CITY OF LEWISTON
PLANNING BOARD MEETING
Monday, July 13, 2020 – 5:30 P.M.
Lewiston City Government
27 Pine Street, Lewiston, ME

RE: Agenda Item 4a, 2019 Lisbon St., Development Review Application for Valley Beverage Building Expansion

**Re: Response to Comments #1
Valley Beverage Building Expansion
2019 Lisbon Street, Lewiston
Map 46 - Lot 12**

FIELD WK: MC/CR	SCALE: 1"=40'	SHEET:
DRN BY: JJM	JOB #: 2714	C4
CH'D BY: CYN	MAP/LOT: 46/12	
DATE: 05-01-20	FILE: 2714-SITE

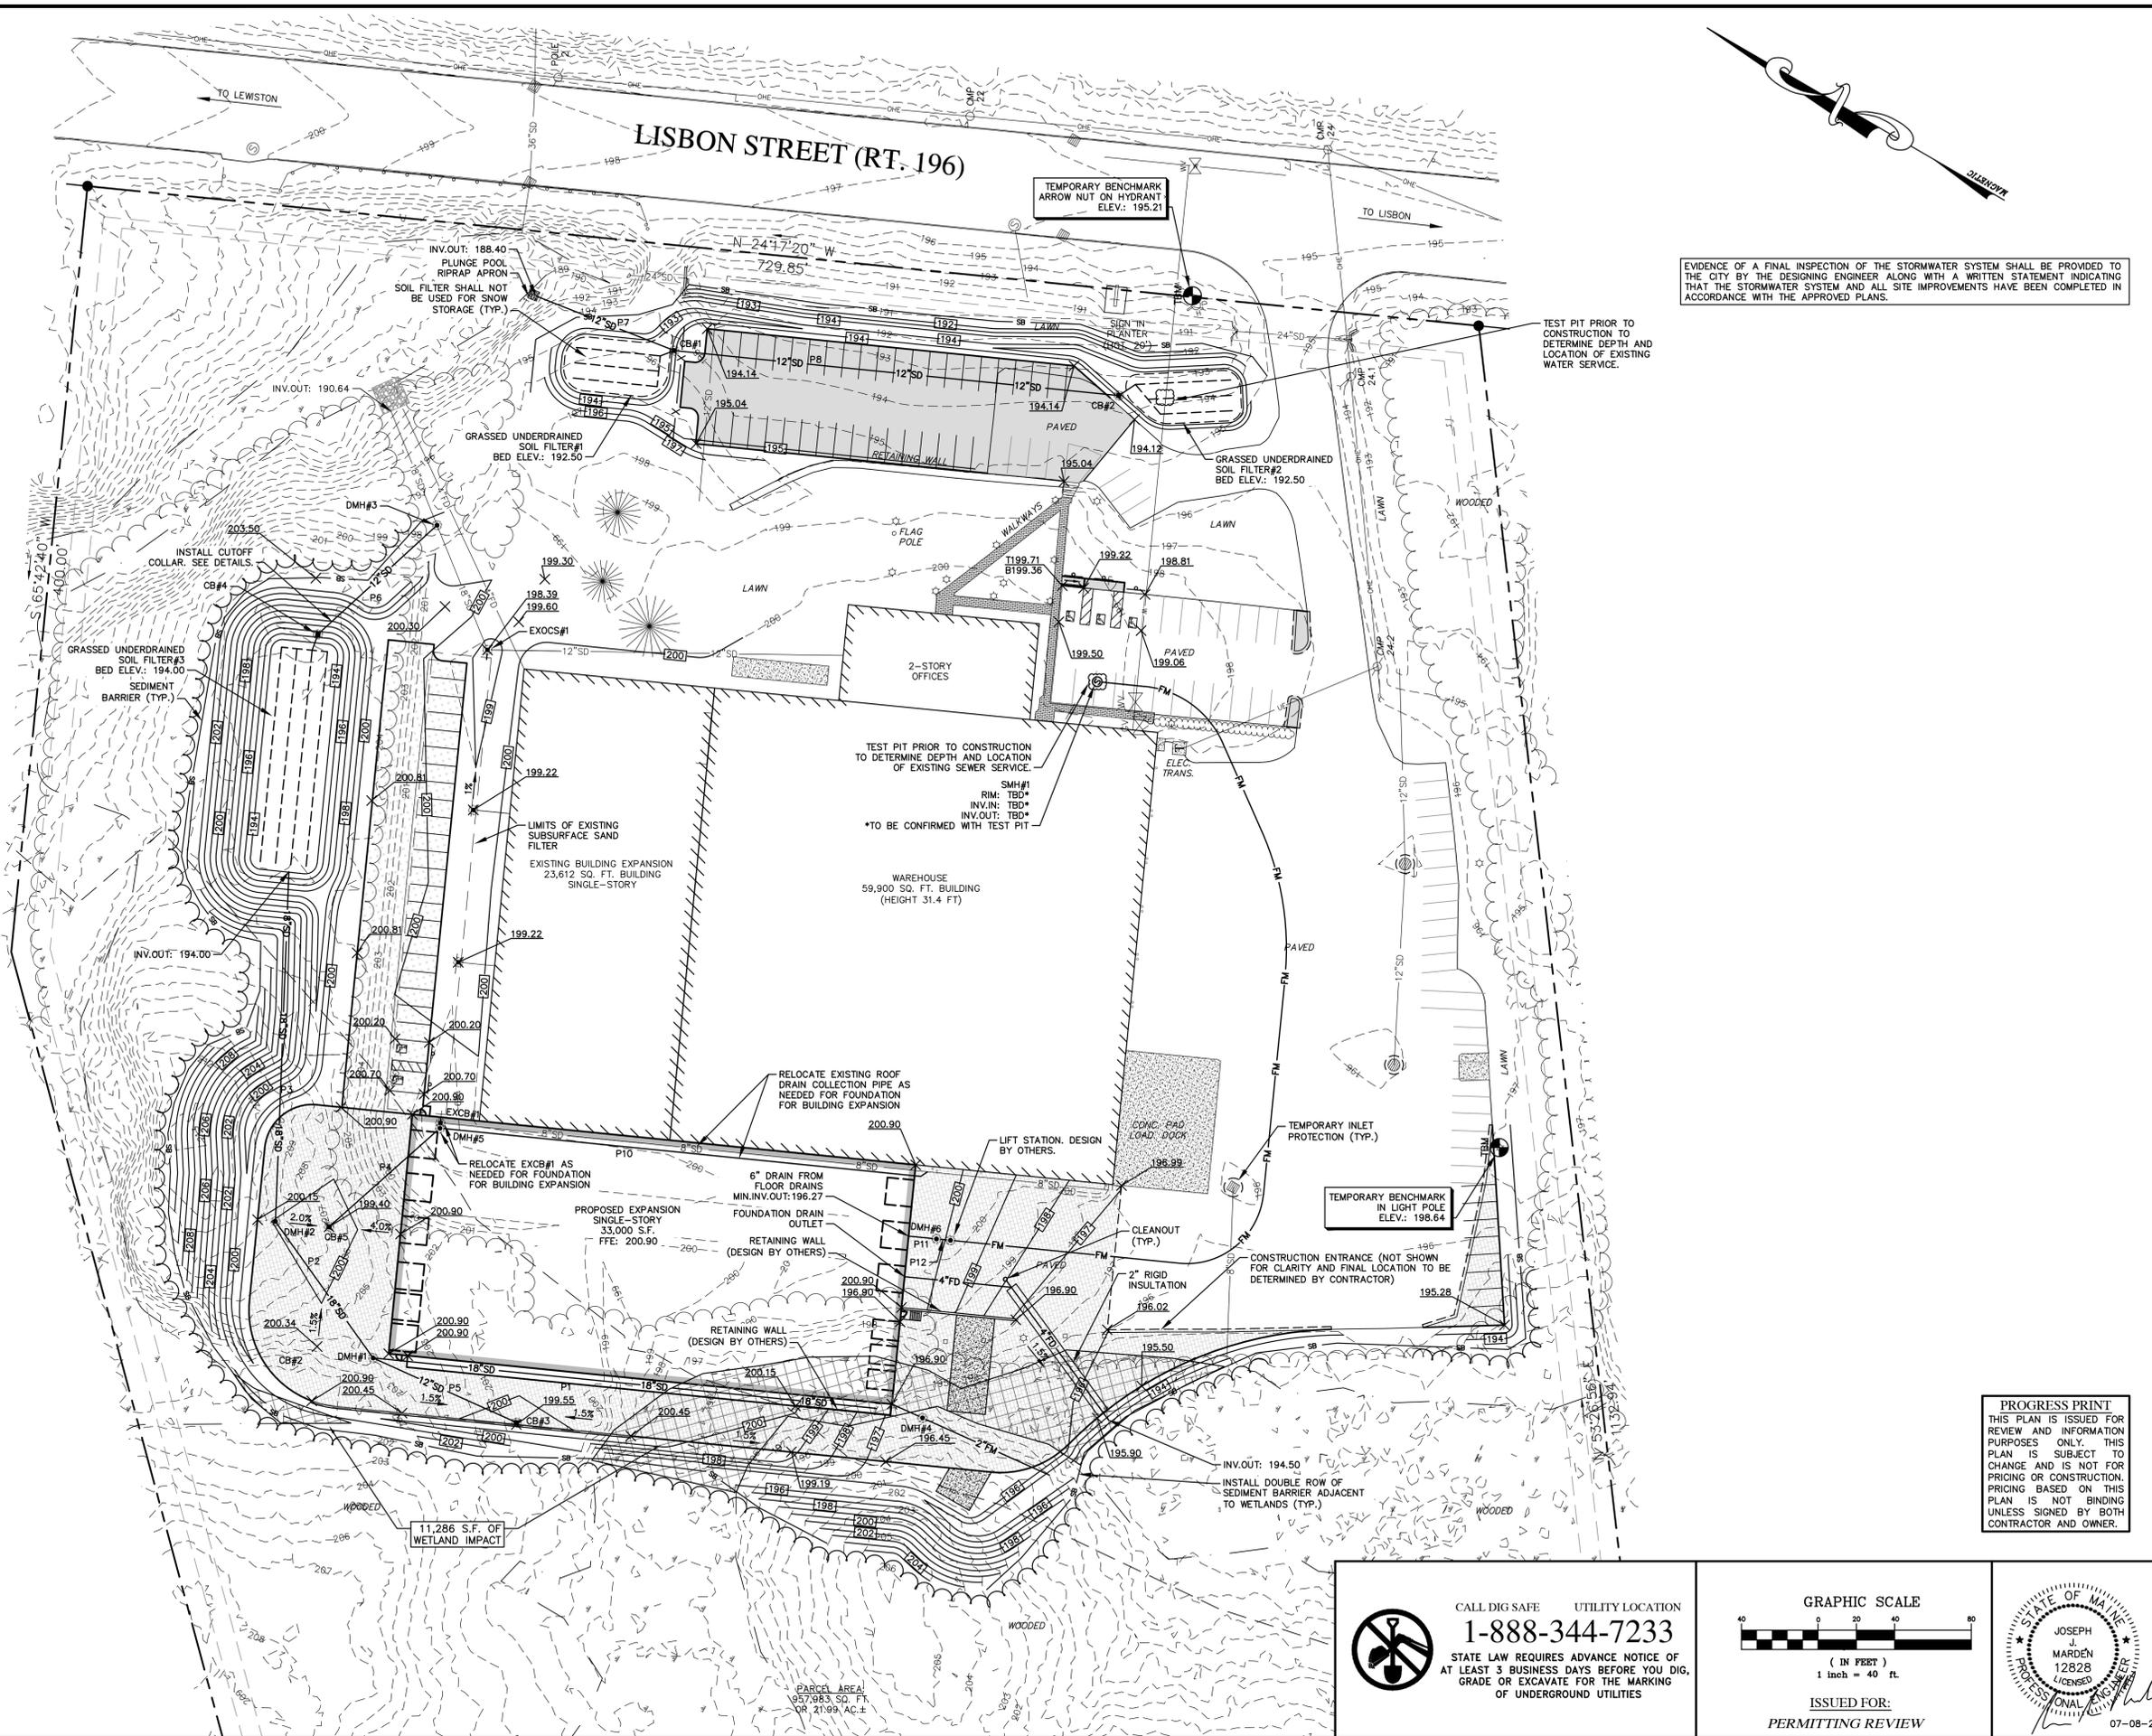
10. *Proposed building addition construction appears to impact the existing subsurface Sand Filter (SSF). The existing SSF should be shown on the site plan and notes/details provided to preserve/protect or modify SSF to maintain the capacity to treat the anticipated volume of stormwater.*

As noted on sheet C4, the drainage structure identified as EXCB#1 will be relocated away from the foundation for the new building addition and is identified on the proposed plans as DMH#5. The existing 8" roof drain collection pipe that currently runs alongside the existing building will be removed and reinstalled away from the foundation for the new building addition. As this pipe will be located beneath the slab within the new building, it will need to be inspected by the Code Enforcement Office for conformance with the appropriate building codes.

The limits of the subsurface sand filter were shown on the previously submitted plans but have been more clearly identified on the enclosed plans. The intent is for the contractor to preserve the existing subsurface sand filter during the construction of the building foundation. A note has been added to the plans indicating that if during the construction process, any modifications to the system are required, the design engineer shall be contacted, and any modifications shall be approved by the design engineer. As shown in the previously submitted Stormwater Management Plan, the subsurface sand filter has excess capacity, and the removal of 2-3 chambers would not impact the functionality of the sand filter system.

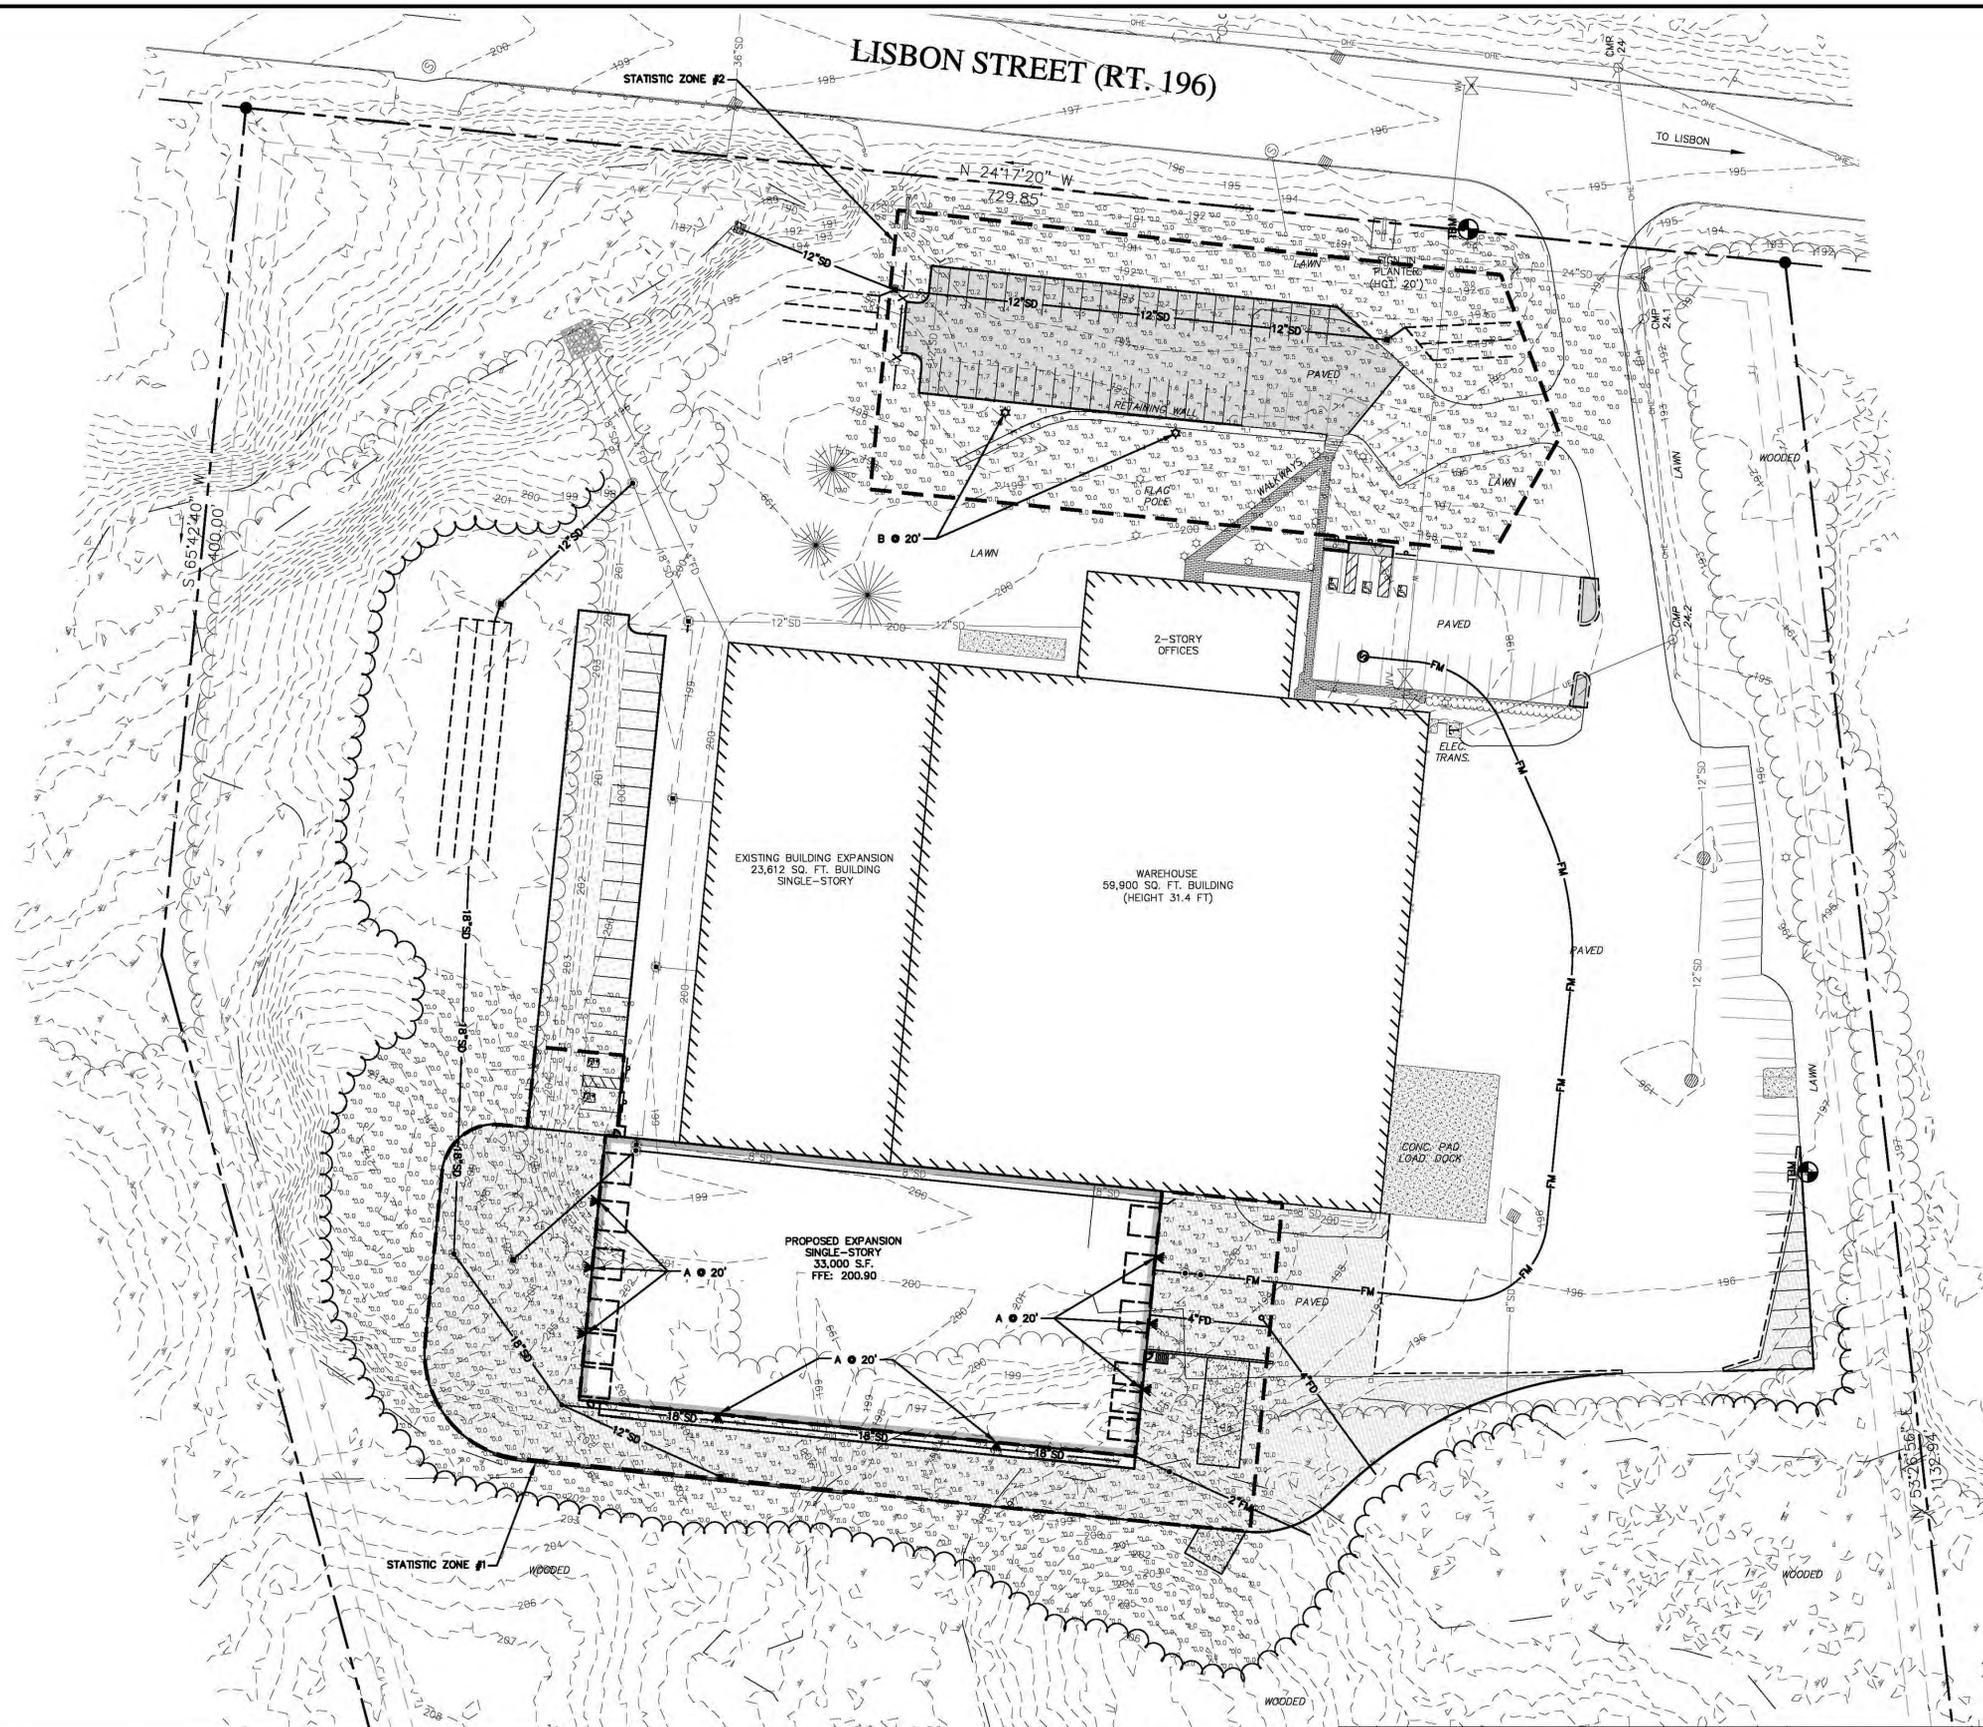
1. Addition a note regarding the storm water system being inspected and that all site improvement have been made in accordance with the approved site plan.
2. No lighting was indicated on the expanded parking lot close to Lisbon Street.
3. Clarification on the Groundwater Protection Plan statistics.
4. Clarification on the parking shortage. The application has recalculated the required parking using only the warehousing parking requirement and reduced the required parking from 148 spaces down to 125 spaces. The Staff is in agreement with the recalculated parking requirement.
5. The new building addition's impact on the existing sub-surface sand filter area.
6. Additional stormwater comments by Public Works were answered in the response by the applicant.
7. Concern about floor drains in the new building addition.

The Lighting Plan has been revised to include two (2) new light poles at the new parking lot along the frontage of the site. The cut-sheet for the lighting fixture has been enclosed with this response letter.
